Powerfuel Portland Ltd

Schedule 5 Response No 1

Figure 28
Annual Mean NOx Impact
Met Data Sensitivity

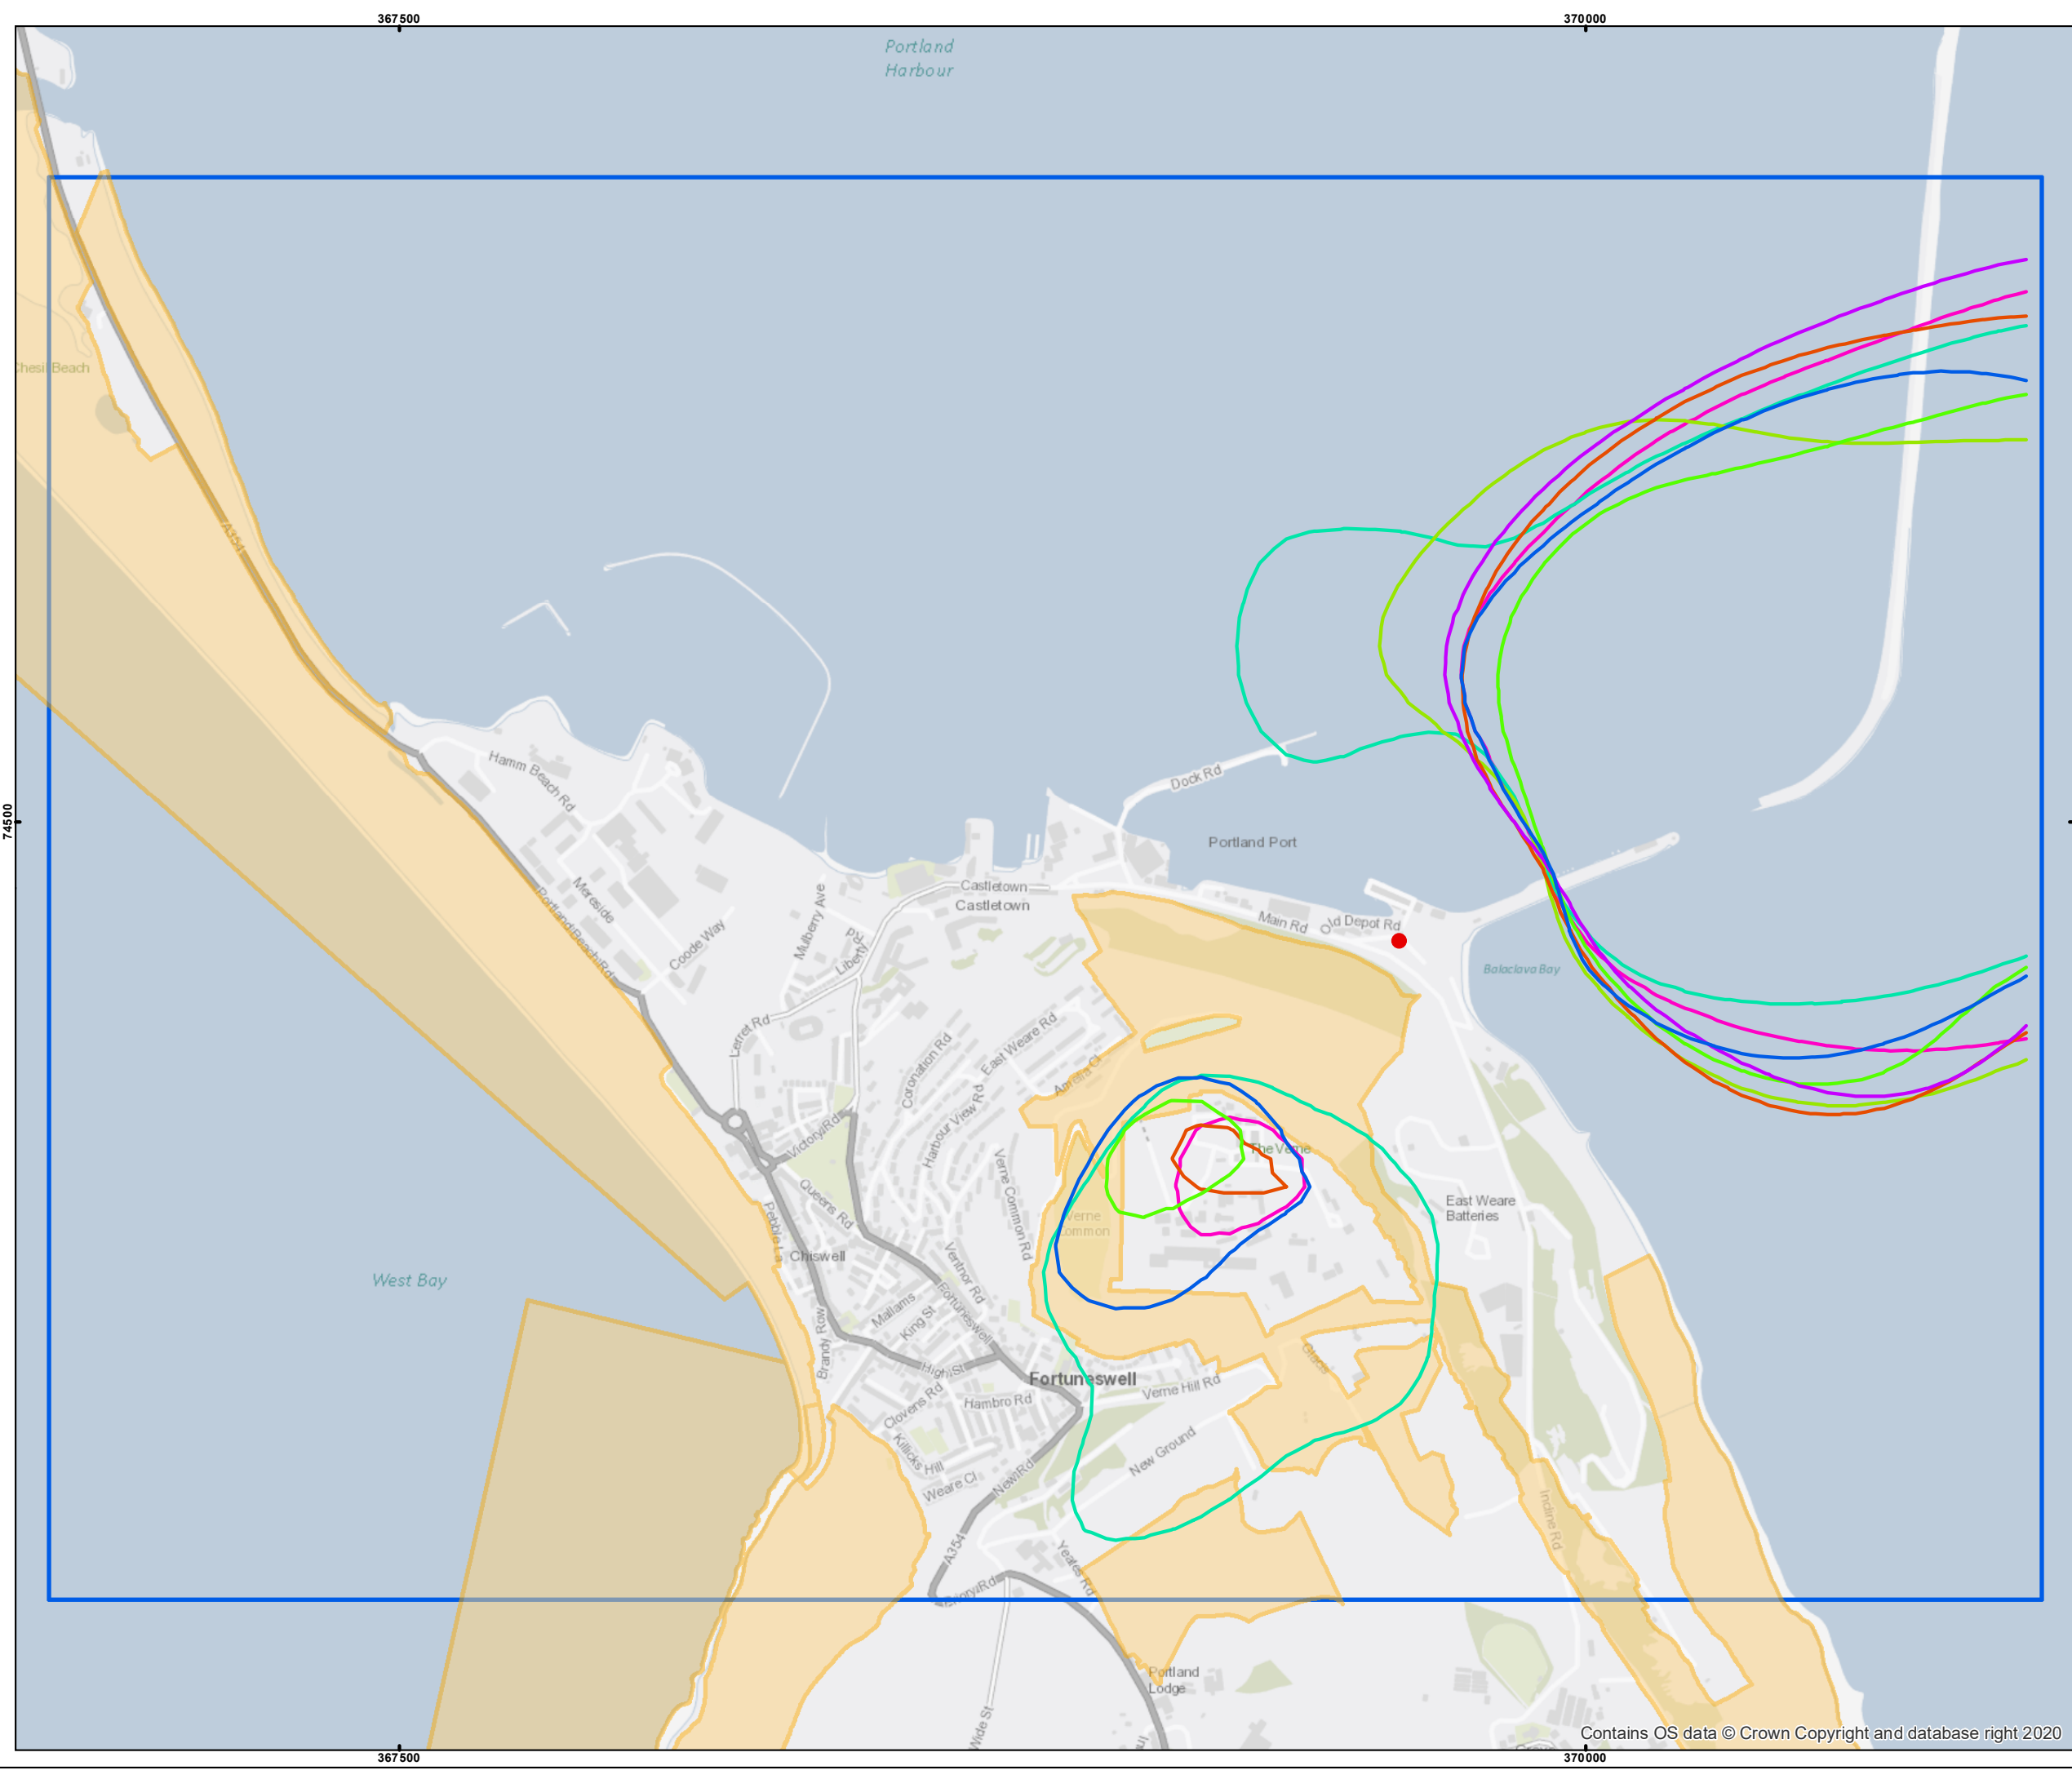
Figure 28, shows the areas where the annual mean NO_x impact is greater than 1% of the Critical Level, and Figure 29 where the maximum daily mean NO_x impact is greater than 10%, using the 5 years of data from the Isle of Portland (as used in the DMA) and the two years of data from Portland Harbour. As shown, using the 2018 data from Portland Harbour results in a larger area of the land where impacts cannot be screened out as insignificant. However, this is away from the port area and the hillside. Using the 2017 data from Portland Harbour, the 1% contour is within the 1% contour using the 2018 data from the Isle of Portland. Therefore, whilst there are some differences between the predicted impacts the change is considered to be within the variability of using different years of meteorological data and the results are considered to be broadly similar.

Figure 30
Model Sensitivity Analysis

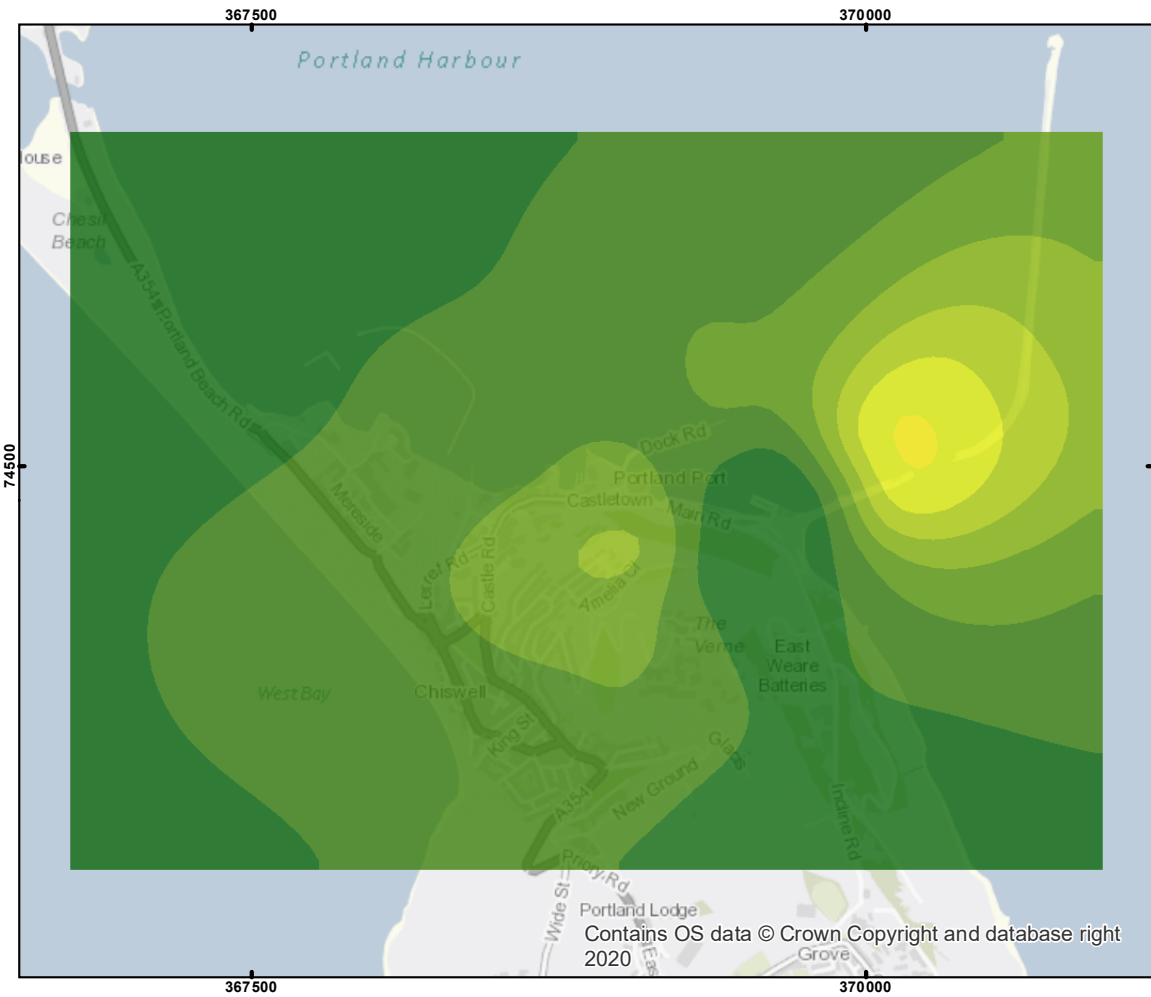
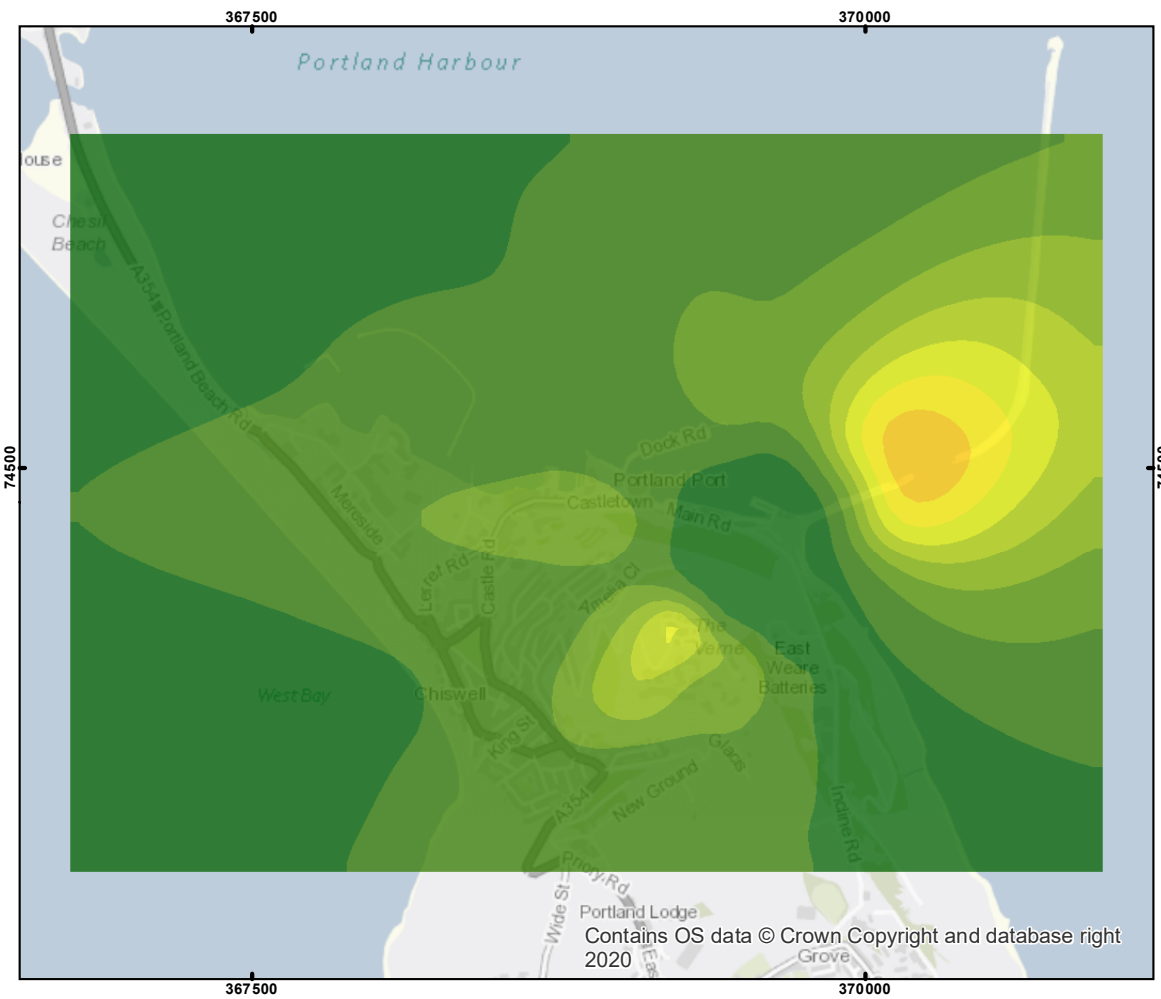
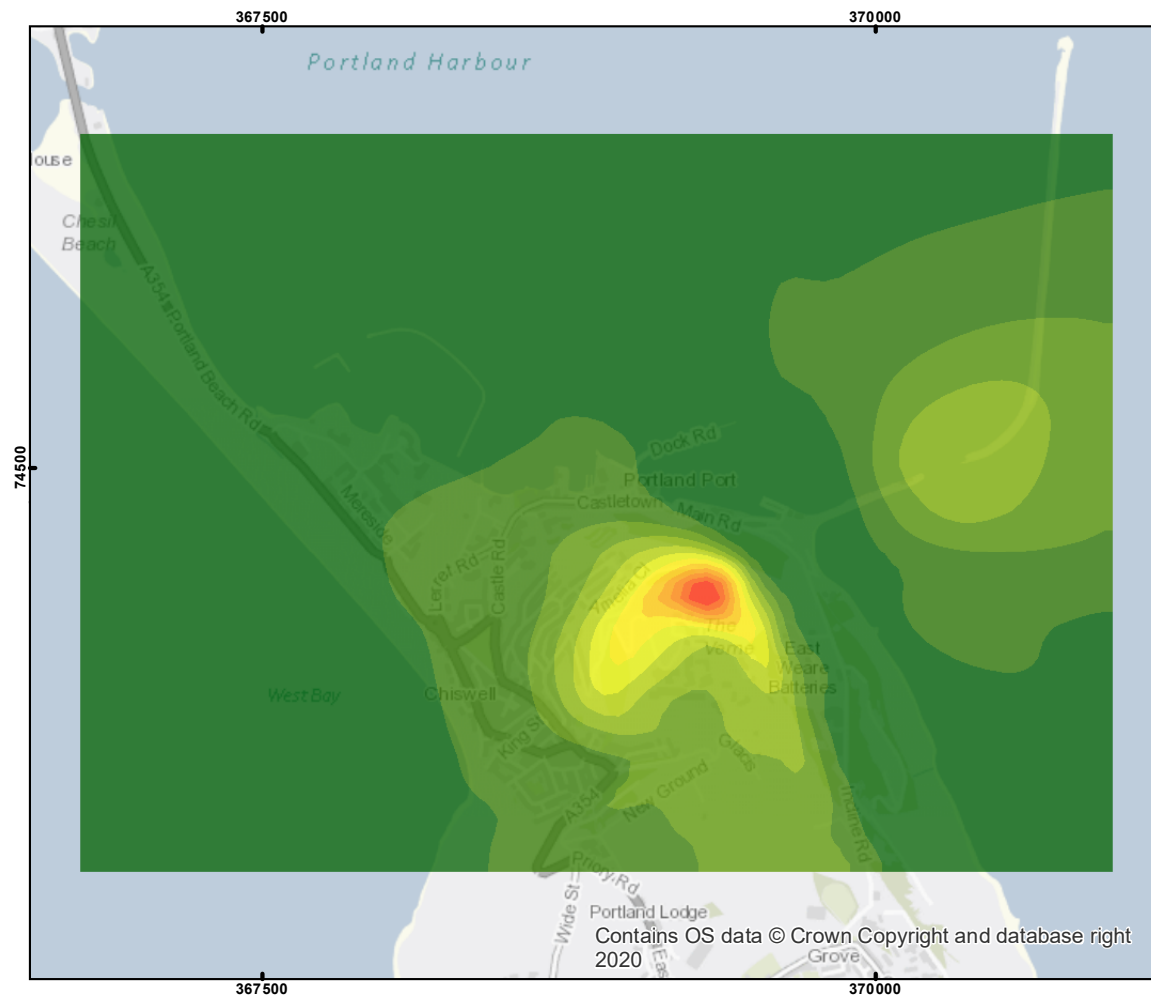
The following table presents the annual mean, maximum 1-hour, 99.79%ile of 1-hour and maximum 24-hour concentration as a percentage of the predicted concentration using ADMS. Figure 30 to Figure 32 contained in Appendix A show the distribution of emissions. Contours have been presented both with and without the effects of terrain included in the model.

The choice of model has a significant effect with significantly higher impacts predicted using AERMOD on the area of elevated terrain close to the plant. However, Fichtner considers that AERMOD is not a suitable model for the terrain around the Portland ERF and therefore considers that the results from AERMOD should be disregarded.
